Project	IEEE 802.16 Broadband Wireless Access Working Group < http://ieee802.org/16 >	
Title	Comments on Mobility Modeling in Draft IEEE 802.16m Evaluation Methodology Document (Section 9.1)	
Date	2007-04-30	
Source(s)	Rob Nikides Fan Wang Motorola	Robert.Nikides@motorola.com fanw@motorola.com
Re:	Call for Comments and Contributions on Project 802.16m Evaluation Methodology, 2007-04-09	
Abstract	This document highlights several areas where the Evaluation methodology is not adequately defined for mobility analysis, proposes modifications for some and suggested course of action for mobility environment definition.	
Purpose	Propose changes to mobility movement and RF environment modeling in Section 9.1.	
Notice	This document has been prepared to assist IEEE 802.16. It is offered as a basis for discussion and is not binding on the contributing individual(s) or organization(s). The material in this document is subject to change in form and content after further study. The contributor(s) reserve(s) the right to add, amend or withdraw material contained herein.

Comments on Mobility Modeling in Draft IEEE 802.16m Evaluation Methodology Document (Section 9.1)

Rob Nikides and Fan Wang
Moto

Figure 1. - 19 cell abbreviated example of MS movement in a wrap around environment. Blue lines denote paired wrap around boundary segment.

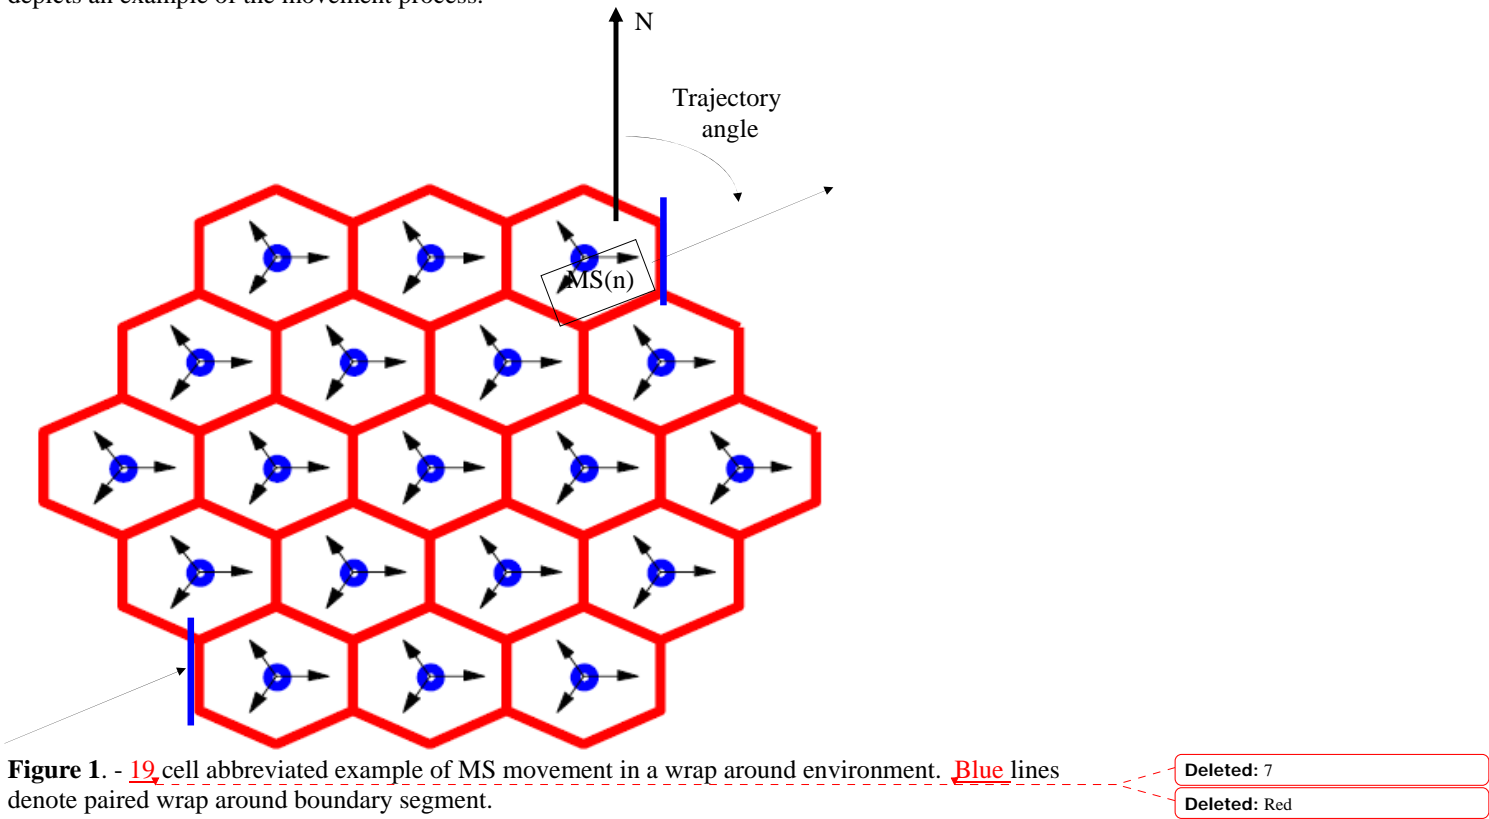
The model of 9.1 defines two travel segments (9.1.2.1 and 9.1.2.2) and limits statistics collection to the center cell for HO operations. Section 9.1.1 further suggests that only a single user per simulation drop is used to collect the array of statistics identified in sections 9.2.1 through 9.2.6. Several problems exist with this technique, of which two are outlined below:

- System is under sampled geographically
- To generate enough HO samples to be statistically significant, the user would have to traverse the stated trajectory many times. Since the path is the same, the failure statistics would be dominated by a very limited sample set of log-normal behaviors. The end result can significantly skew the end HO related statistics to either good or bad extremes. This fundamentally results in the inability to compare results from different vendors reliably

Movement of the MS is established by selecting a random speed for the users according to profiles in section 4.3.1 such that the population of MS users meets the desired percentages. The MS remains at the selected random speed and direction for the duration of the simulation drop. When a MS crosses a wrap around boundary point within the simulation space, the MS will wrap around to the associated segment identified within Appendix G, continuing to keep the same speed and trajectory. Figure 1 depicts an example of the movement process.

Figure 2 – Simplified representation of plane based approach to RF environment modeling

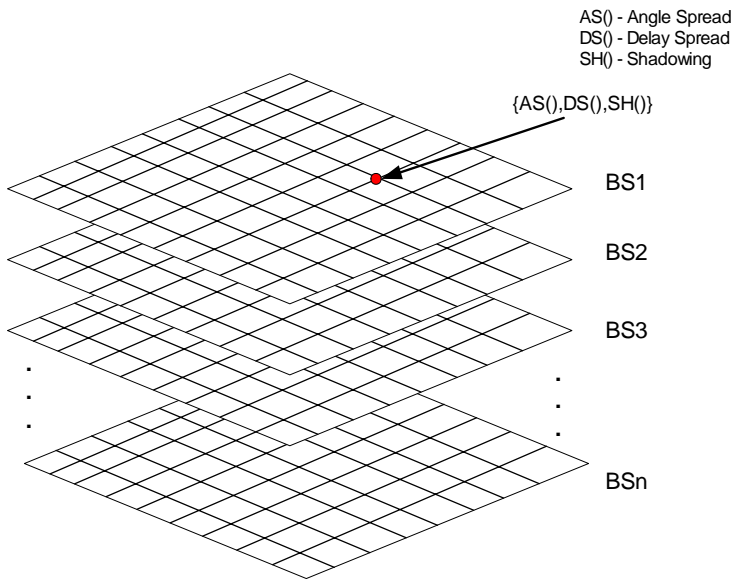
Current section 9.1 also describes a generic pathloss scenario for the two defined trajectories. Lacking in this description though is specifics on how the parameters angle of arrival, delay spread, and shadowing are modulated as the user moves through the environment. The text instead refers to the RF modeling contained elsewhere. Unfortunately, the RF modeling specified is tailored to the methodology of dropping a user at a location and calculating a set of parameters for the user at the location. (see Step 3 on pg. 34 and Appendix A.) The currently specified models only define the relative correlation between BSs and correlation between angle spread and shadowing.

The second part of this proposal is to generate an RF model that reflects the transitional behavior of a real system, including de-correlation distance and the already modeled site to site correlations. One method to accomplish this is through a set of planes, with each plane representing the environment of a given site and/or sector over the simulation space. The planes are divided up in a uniformly spaced grid, using the de-correlation distance to define the desired spacing of sample points. Each point on the grid represents a triplet of angle spread, delay spread, and shadowing parameters. MS locations between the grid points are interpolated. The shadow values are then applied over the defined pathloss models. A visual representation of the model appears in figure 2.

In addition to the plane representation, a distance_traveled_for_update parameter is also supplied to quantize the RF update interval (based upon distance traveled).

Figure 3. - 19 cell abbreviated example of MS movement in a wrap around environment. Blue lines denote paired wrap around boundary segment.

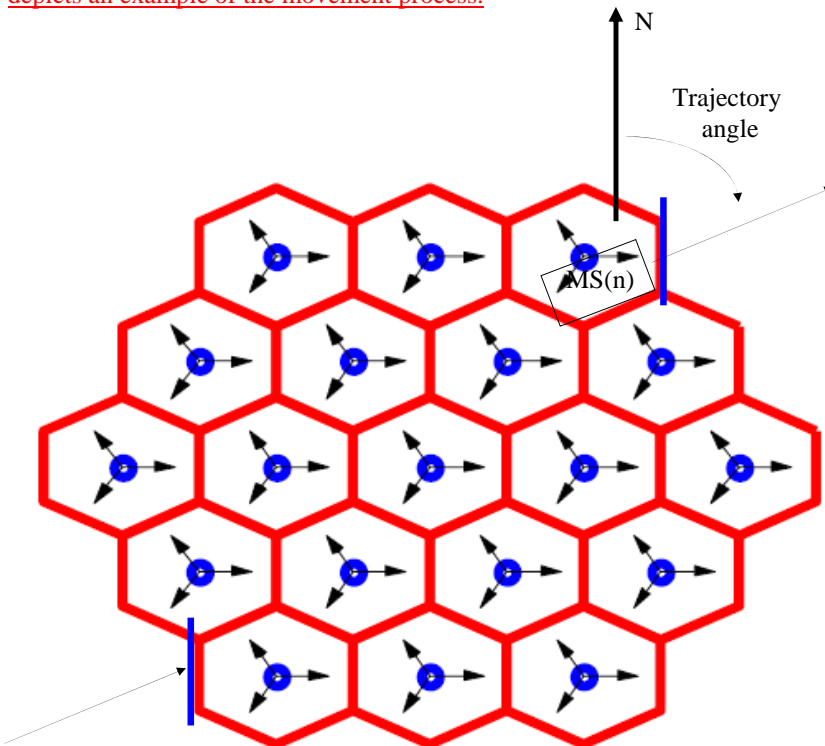
Propose adding following text in Section 9

Each MS is assigned an angle of trajectory at the beginning of a call. The assigned angle is picked from a uniform distribution across the range of 0-359 degrees in one degree increments. The angle of zero degrees points directly North in the simulation environment.

Movement of the MS is established by selecting a random speed for the users according to profiles in section 4.3.1 such that the population of MS users meets the desired percentages. The MS remains at the selected random speed and direction for the duration of the simulation drop. When a MS crosses a wrap around boundary point within the simulation space, the MS will wrap around to the associated segment identified within Appendix G, continuing to keep the same speed and trajectory. Figure 3 depicts an example of the movement process.

Figure 4 – Simplified representation of plane based approach to RF environment modeling

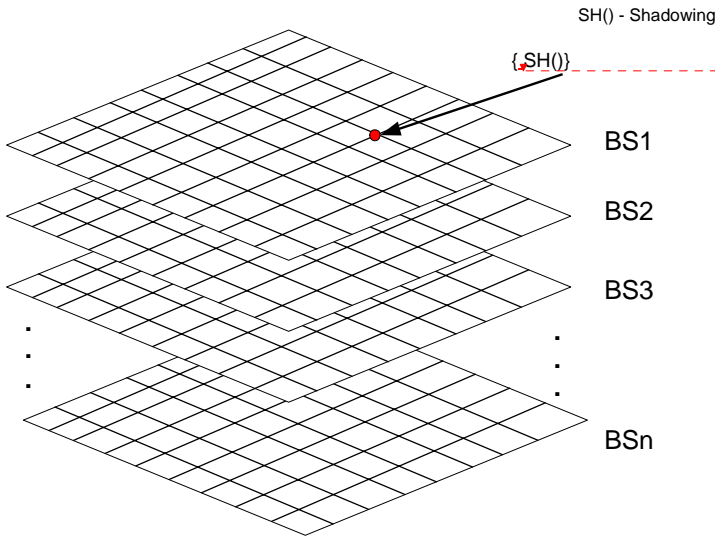
Propose adding following text in Section 4, in a sub-section regarding shadowing factor modeling

For each base station, a plane of a uniformly spaced grid is generated as shown in Figure 4. The distance between closest nodes in the grid is the pre-defined de-correlation distance. Each node on the grid represents an independent shadowing factor. For a case of spatial channel model, the angular spread and the shadowing factor on a node should be generated jointly according to Appendix-A. For a case of non-spatial channel model, the shadowing factor on a node should be generated according to comment-086. For a mobile location, either from a random drop or a result of mobility, the shadowing factor from the mobile to a base station should be calculated by linearly interpolating the shadowing factors of the closest four nodes on a corresponding plane in Figure 4.
